ASSESSMENT REPORT

Glen Innes Wind Farm Modifications

Modification 2 (07_0036 MOD 2)
Modification 3 (07_0036 MOD 3)

Figure 4: Proposed turbine locations

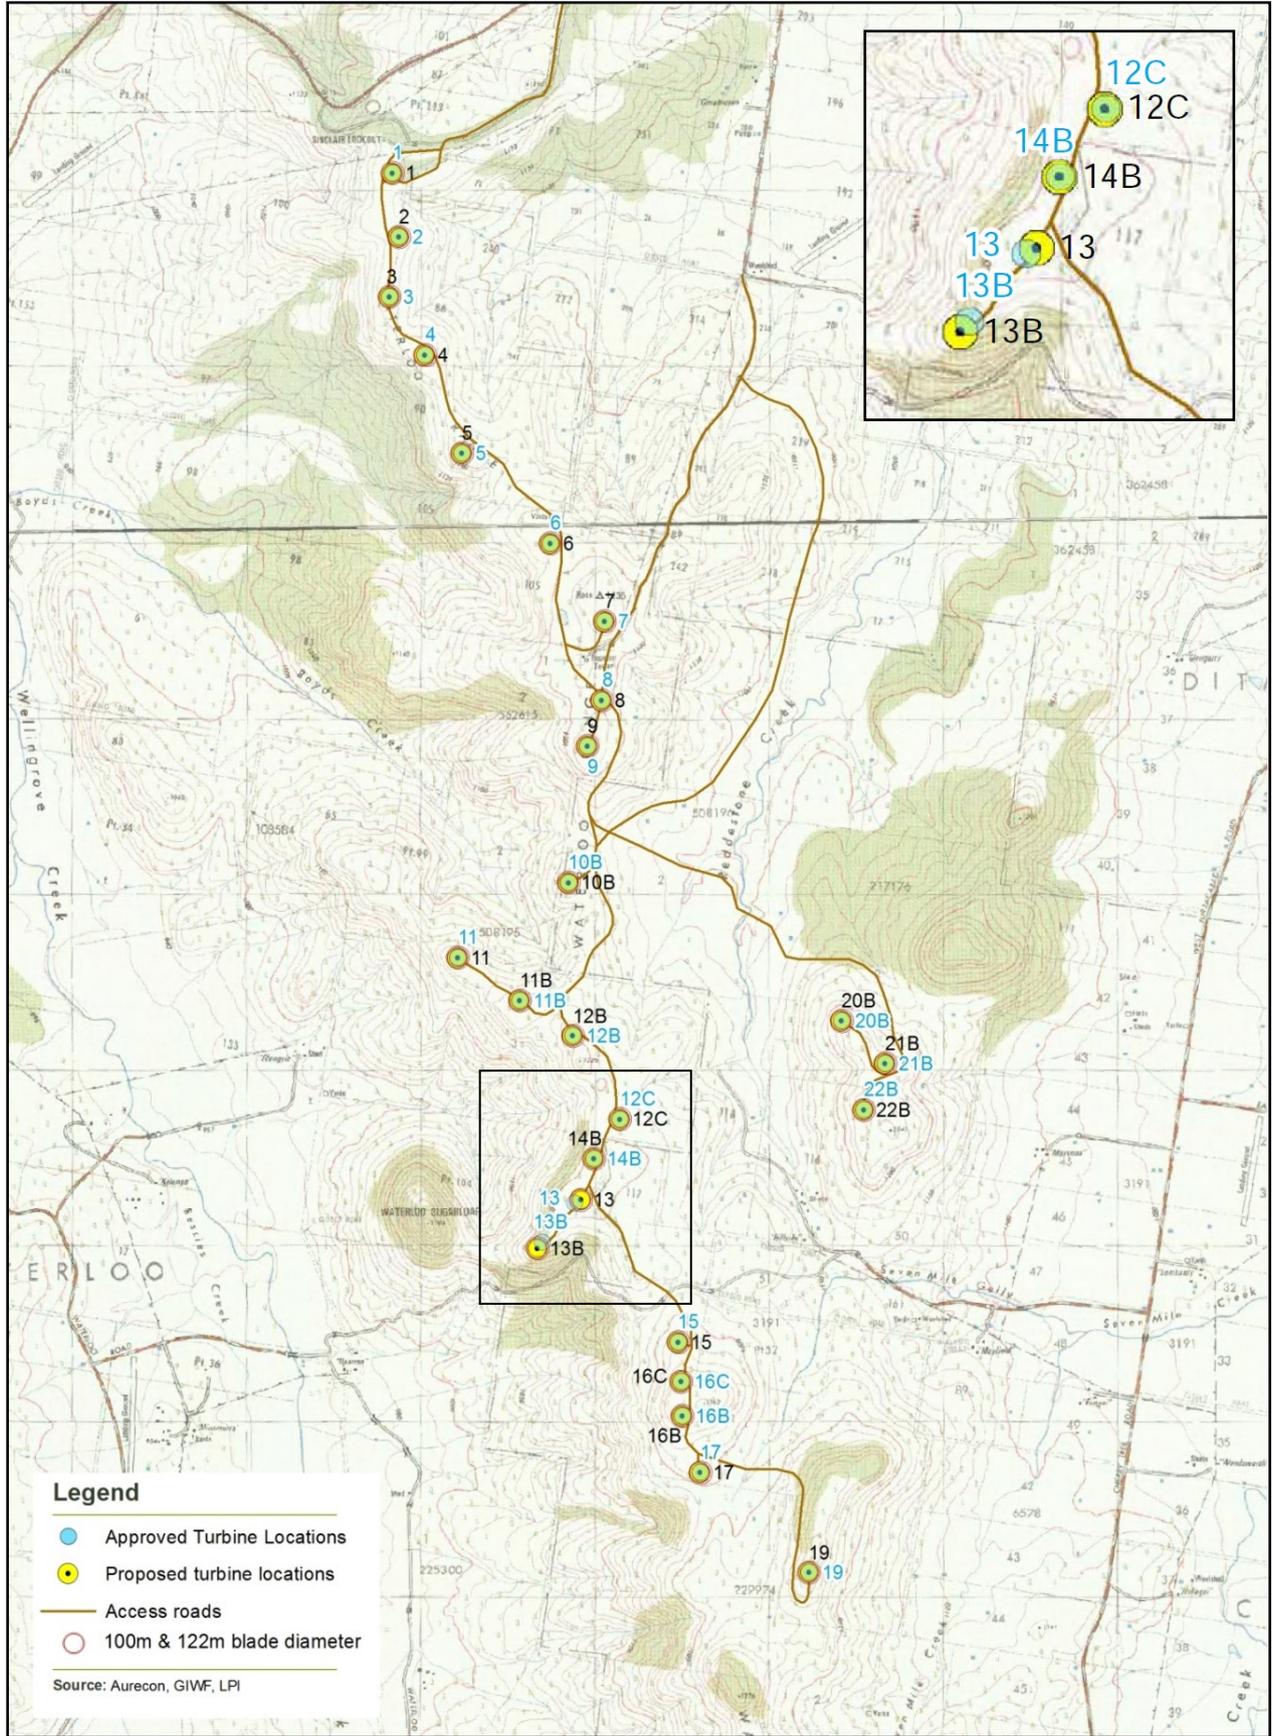
Turbine No. 13 is proposed to be micro-sited 43 m in a north easterly direction and Turbine No. 13B is proposed to be micro-sited 44 m in a south westerly direction as shown on Figure 4.

Department of Primary Industries (DPI) including Crown Lands, noted that the relocated Turbine No. 13B and 14B, combined with their proposed increased size, brings their reach within close proximity to, and potentially over, crown roads. The increase in blade diameter may also put blades over a section of crown road at the northern end of the project area. It advised the proposed changes would require clarification regarding interactions with these crown roads.

The Department notes that the modified turbine locations combined with the increased blade diameter could result in a number of turbines potentially impacting segments of unformed Crown road reserves, as raised in the submission from DPI. In particular, the blade diameters of Turbine Nos. 1, 13 and 14B would potentially extend over segments of unformed Crown road reserves in their vicinity. The unformed Crown road reserves would be able to be avoided through micro-siting during the detailed design stage of the project. The Department has recommended a condition requiring GIWP to ensure the future use of any unformed Crown road reserve is not compromised by the project.

Figure 13: Transport route options

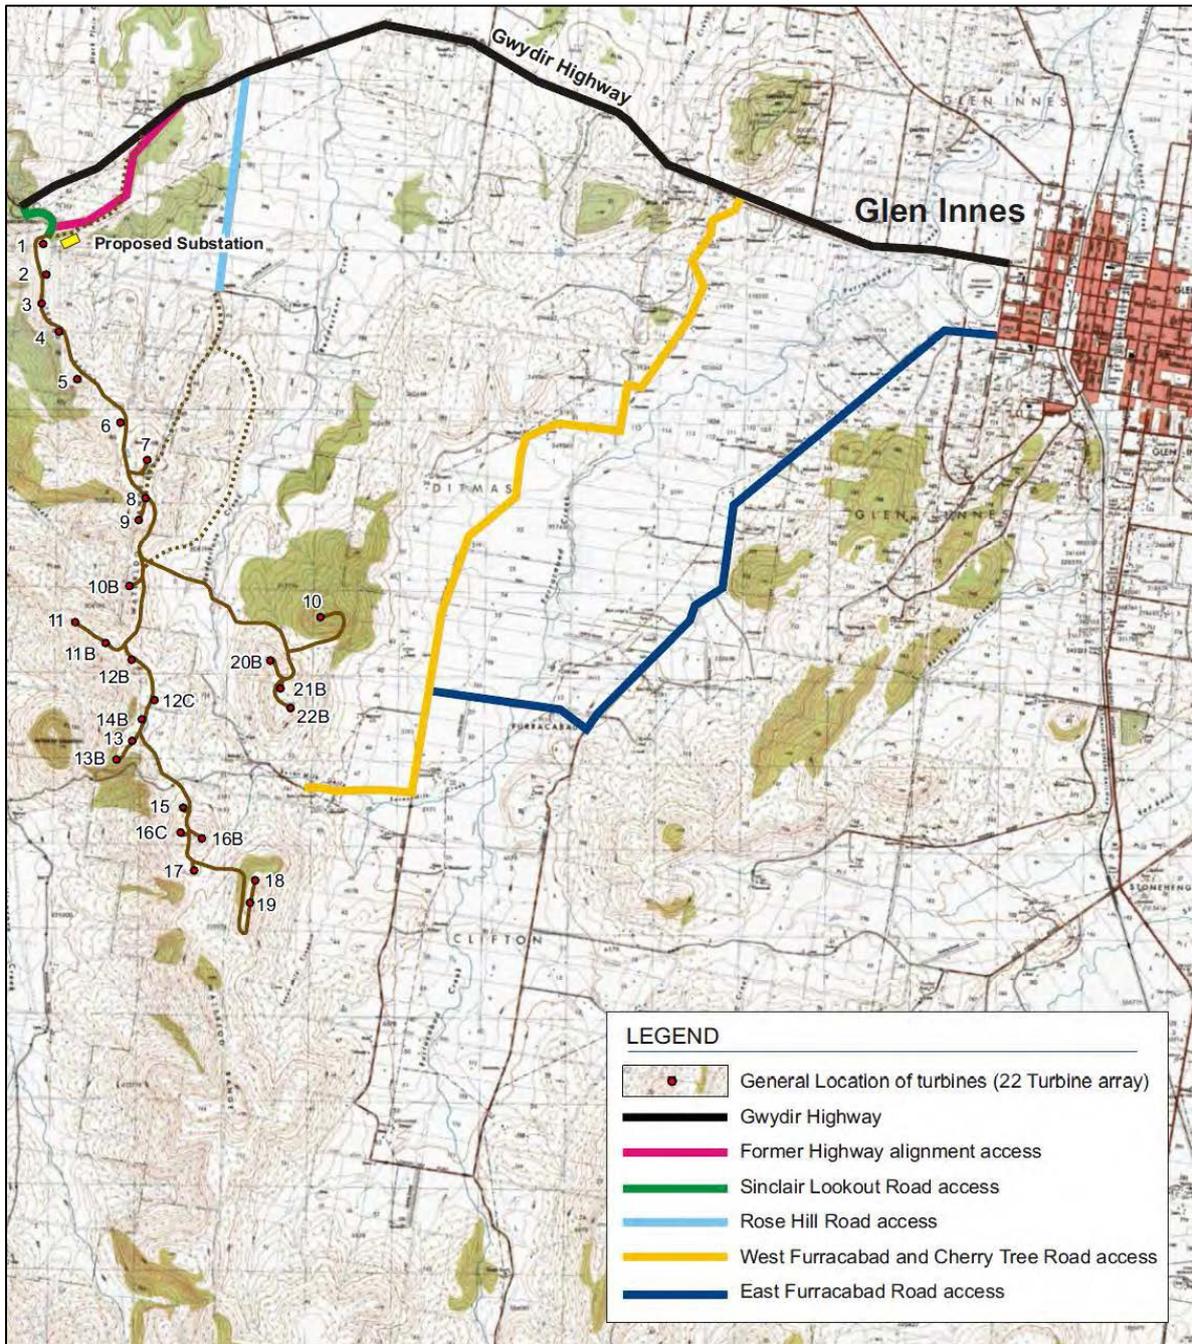
As Modification 2 seeks to use larger wind turbine components, increased turning restrictions are anticipated with an overhang expected for the transportation of the blade.

A traffic assessment, inclusive of swept path assessments (in both the EA and Response to Submissions for Modification 2) of the largest vehicles was undertaken to determine the feasibility and accessibility of the vehicles along the transport route along the Gwydir Highway and New England Highway, in accordance with the existing conditions of approval. This transport route is shown on Figure 12 and Figure 13.

The assessment concluded that there would be key locations where manoeuvring constraints for the transportation of the wind farm components would be experienced, however these could be mitigated with the implementation of appropriate traffic management measures for the use of oversize/overmass vehicles. These include appropriate markings and signs for special purpose vehicles, the use of pilot and escort vehicles and the use of warning lights and signs.

The Department is satisfied that the traffic and transport impacts of the modified project have been satisfactorily addressed by GWP, and considers that the modified project would not result in any significant additional impacts. The impacts would be adequately managed through the existing conditions of approval which include restrictions regarding access to the project site, require approval from the relevant roads authority for the use of oversize/overmass vehicles, require all the relevant roads approvals to be obtained prior to commencing work and require a Road Dilapidation Report and detailed Construction Traffic Management Plan.
